RE: Permit #: PRCOM20190589
Our Lady of the Presentation Addition and Renovation
Lee's Summit, MO

PLAN REVIEW NOTES/COMMENTS:

A681

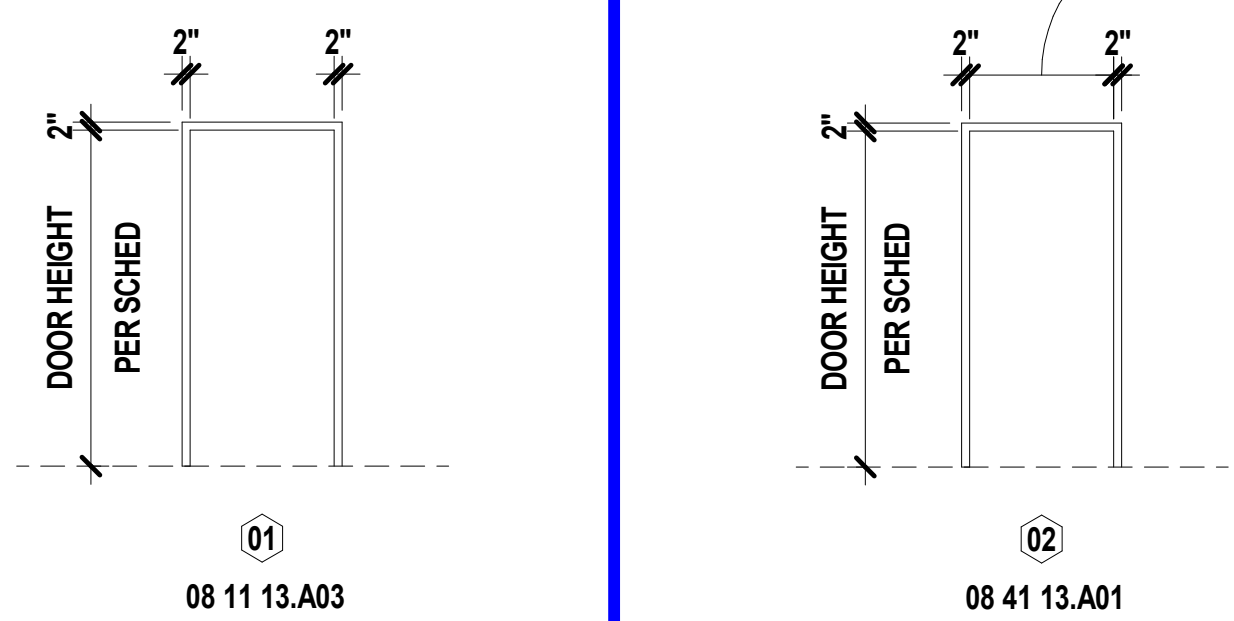
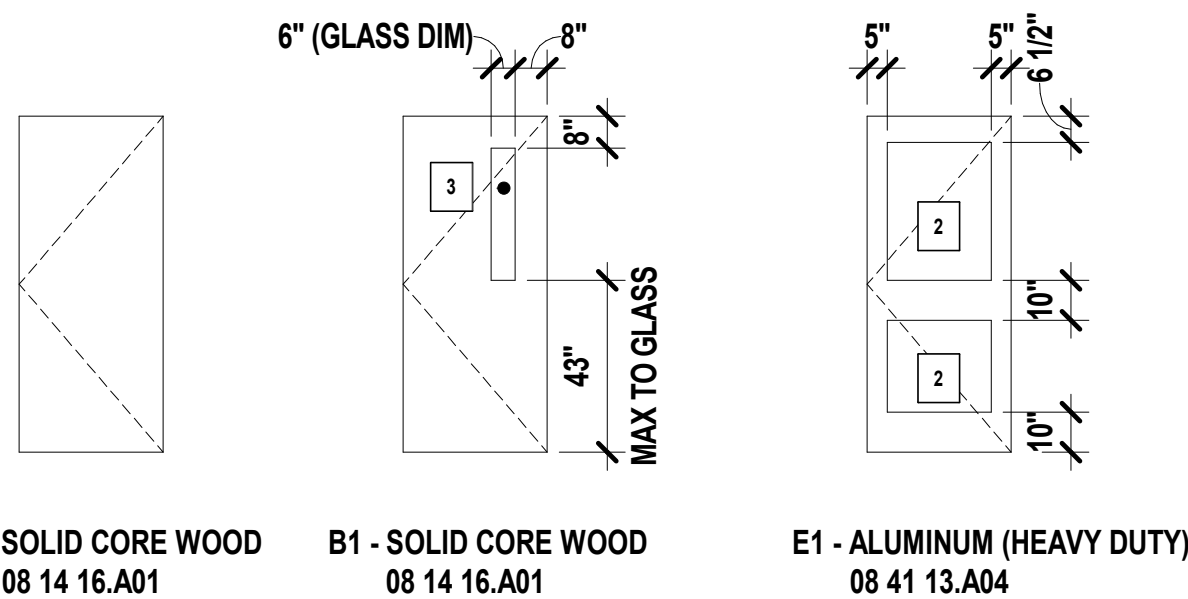
13 2012 IFC 1008.1.10 Panic and fire exit hardware. Doors serving a Group H occupancy and doors serving rooms or spaces with an occupant load of 50 or more in a Group A or E occupancy shall not be provided with a latch or lock unless it is a panic hardware or fire exit hardware.

Response: Exit door A103b is specified to have panic hardware per DOOR HARDWARE 087100 – 9. Door Schedule (A681) is updated and attached to correspond. Door X101a is existing and has panic hardware is in place. Door Schedule (A681) is updated to note this.
